## P R O D U C T   B U L L E T I N

**Bulletin No:** PB218

FR1418 BGA Rework System

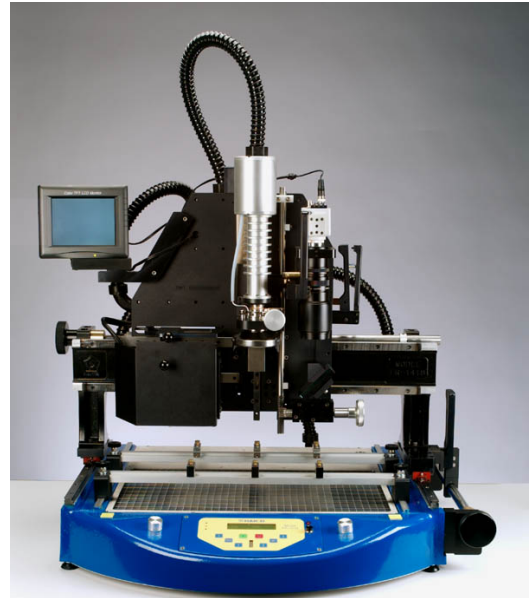
Top heating element has been changed from 850 watts to 1000 watts. Total amps for FR1418-01 (15 amps) and FR1418-02 (20 amps) has not changed.

To improve performance, specifically with lead-free solders, the top heating element has been upgraded to a 1000 watt heater. This will speed the process time when working at higher temperatures for lead-free solders.

Effective with units manufactured after June 1, 2005 (S/N 023 and higher)
